Mr. Hans Jürgen Stehr
Chair, CDM Executive Board
UNFCCC Secretariat
CDMinfo@unfccc.int

21 December 2007

Re: Request for Review "Beijing Taiyanggong CCGT Trigeneration project" (Ref. No. 1320)

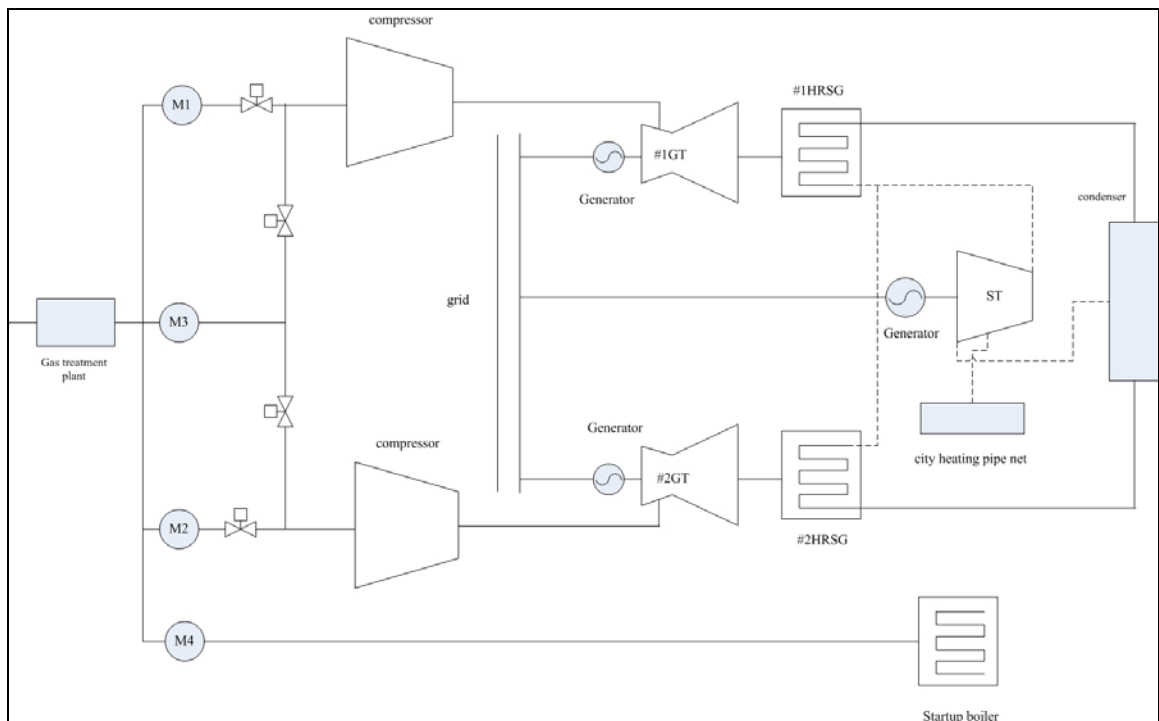
Issue 14. The monitoring plan should specify the means of determining the natural gas and diesel consumption.

- **Gas consumption monitoring:** Gas consumption will be measured using gas flow meters. These will be maintained and calibrated regularly according to Chinese regulations and standards. As detailed in annex 4 of the PDD, there are four meters monitoring gas consumption: meters 1 and 2 measuring gas to each compressor and a meter 3 as a back-up. Meter 4 measures gas sent to the start-up boiler. Gas consumption will therefore be calculated by:

$$FC_{\text{Gas}} = M1 + M2 + M4$$

M3 will act as a back-up in case of failure of M1 or M2. As a further back-up, sales receipts of gas supplied by the gas company will be used. The gas meters will automatically compensate for changes in temperature and pressure of the natural gas so that FC_{gas} is given at normal temperature and pressure.
